Maintenance Manual DG-300

0.1 Amendments

No.	Page	Description	Date
0.1	all	Combination of the initial Maintenance Manuals of the Variants DG-300, DG-300 ELAN, DG-300 ELAN ACRO, DG-300 Club ELAN and DG-300 Club ELAN ACRO, new standardized format	December 2009
0.2	0.7, 1.10, 1.12, 2.1, 2.4, 3.2, 4.1, 4.2, 5.1, 5.2, 6.1, 6.2	Miscellaneous changes to the contents of the latest amendments of the initial maintenance manuals	December 2009
1	0.1, 0.3 – 0.8, 1.4, 2.1, 6.3, 8.8 – 8.12, 9.9 – 9.12	TN DG-SS-05 Manual revision Inclusion of TN359/4 and TN359/24	August 2020
2	0.1, 0.3, 1.2, 1.3	TN DG-SS-09 adjustment of elevator free play	December 2023

see diagram 1

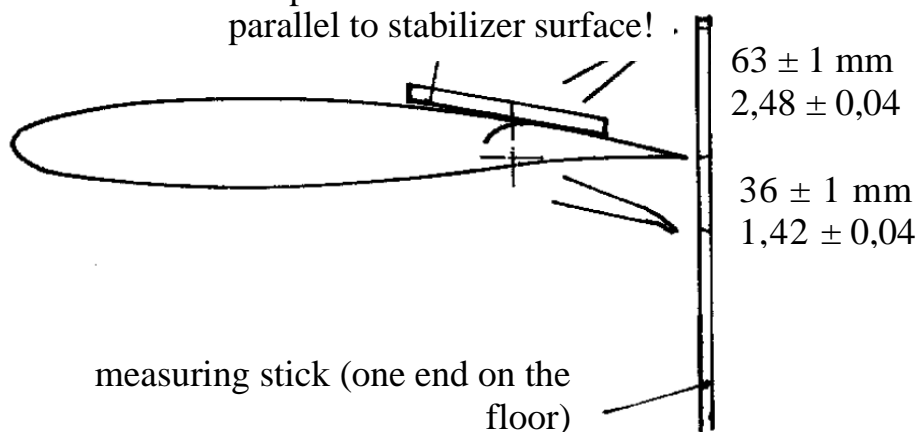
1.2.4 Elevator control circuit free play:

The play at the top of the control stick must not exceed ± 1.5 mm (± 0.06 in.) when the elevator is firmly held in neutral position.

Within the automatic elevator connection there should be no free play noticeable in the zero position when the elevator is moved at its trailing edge.

Any free play can be reduced by screwing in the adjustment screw on the automatic connector funnel.

Warning: In case the adjustment screw was turned in too far, the roller will jam inside the funnel and can't be moved or only with larger force to the front of the funnel. Moving the horizontal tailplane backwards for rigging might not be possible or only with large effort. Each time a bending force will act on the rod end which might lead to failure of the rod end with time.

For this reason after adjusting the free play it is necessary to check if the roller can be moved without force in the funnel.

To accomplish this, remove the complete rod end with the roller or remove the roller from the rod end and stick it on an 8 mm f7 pin and move the roller in the funnel. Prior to removal of the rod end mark its position.

If the roller can't be moved without force completely to the front you must turn back the adjustment screw and bend back the sheet metal which was bent by the adjustment screw. Then adjust the free play again.

In case the roller has too much free play on the rod end or if the roller is no more round you must replace the roller by a new one 2L24.

In case the glider was operated for a longer time with the adjustment screw turned in too far the rod end must be replaced by a new one 2L19/1.

After completion of this work check the elevator displacements and adjust if necessary.

1.2.6 Repair of the automatic trim mechanism bowden cable:

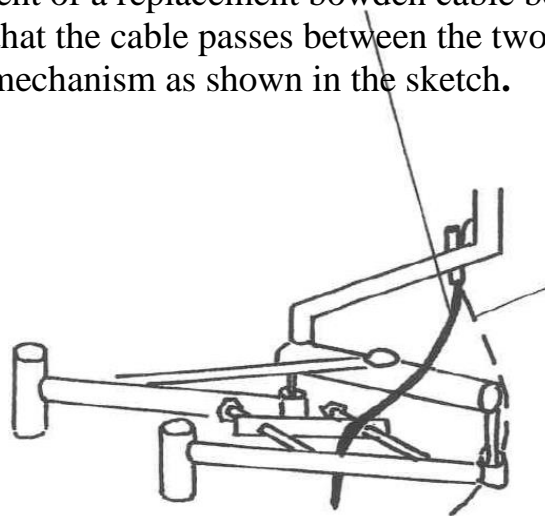
In the event of a replacement bowden cable being installed, it should be ensured that the cable passes between the two parallel arms of the control column mechanism as shown in the sketch.

Note: if the cable passes outside the mechanism control column movement could be blocked
